CONTINENTAL MOTORS® AIRCRAFT ENGINE SERVICE INFORMATION LETTER

CATEGORY 5
SIL17-03

SUBJECT: Oil Filter, Anti-Stick Gasket

PURPOSE: To notify owners, operators, distributors, and maintenance facilities of

Figure 1. Oil Filter Label (Anti-Stick Gasket)

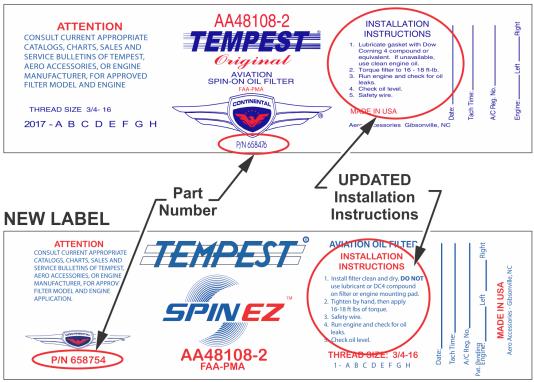
Continental Motors, Inc. (CMI) introduces a new improved oil filter with an anti-stick gasket as an equivalent to existing oil filters (see Table 1). The new filter allows easier removal of the filter during maintenance activity.

1. Reference the latest version of the Illustrated Parts Catalog (IPC) for updated part numbers. Verify the correct replacement part number against the superseded oil filter (reference P/N filter label, see Figure 1).

2. Replacement filters (see Table 1) should only be installed on a clean and dry surface. Clean and dry the oil filter adapter assembly mating surface to remove any residual gasket coating, lubricant, or sealant compound, if applicable.

CAUTION: Do not apply lubricant or sealing compound to the new replacement filter gasket. Applying any lubricant or sealing compound to the replacement filter (see Table 1) may adversely affect the gasket's anti-stick properties.
